Front Suspension – Knocks –
New “V” Mount Introduced

MODEL 1995 MY
Sedan Range
VIN
720001 - 722757

ILLUSTRATION 1

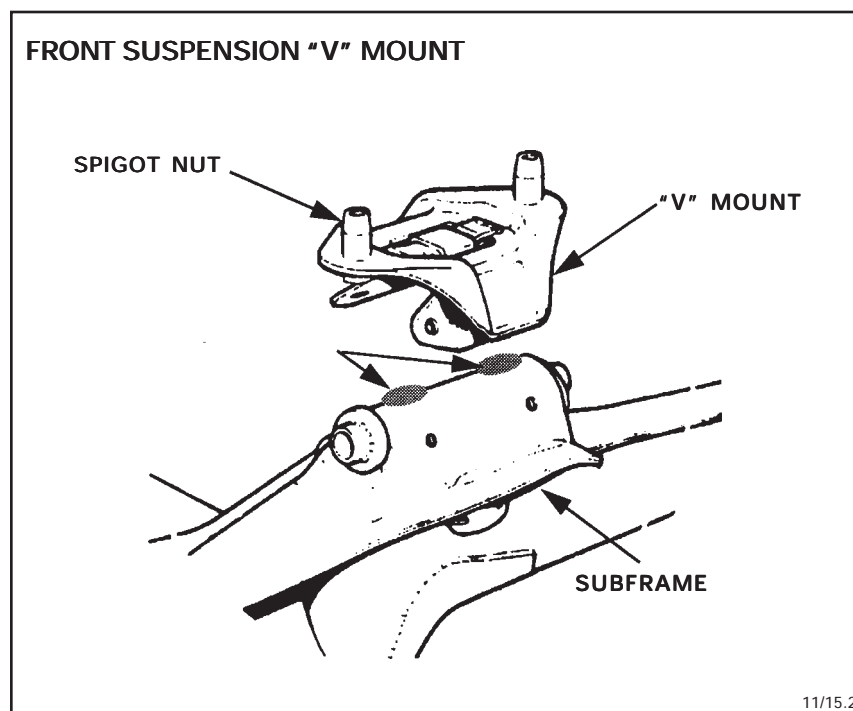
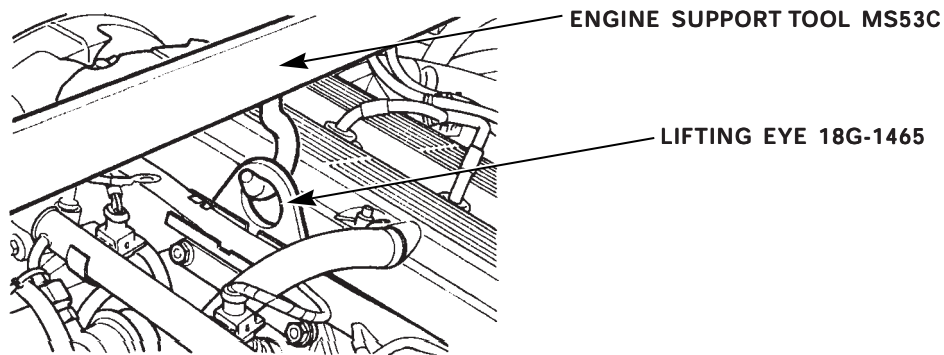
Knocks or rattles from the front suspension of 1995 MY Sedan Range vehicles within the above VIN range may be caused by the front suspension “V” mount spigot nuts contacting the front subframe (crossbeam). A new “V” mount with shorter spigot nuts was introduced in production at VIN 722758.

If a customer complains of a hard knock from the front suspension of a 1995 MY Sedan Range vehicle within the above VIN range when driving over a rough road surface, check for evidence of contact between the front suspension “V” mount spigot nuts and the front suspension subframe (Illustration 1). If contact is found, replace the existing front suspension “V” mounts with new “V” mounts (part number MNA 2360AD) as follows:
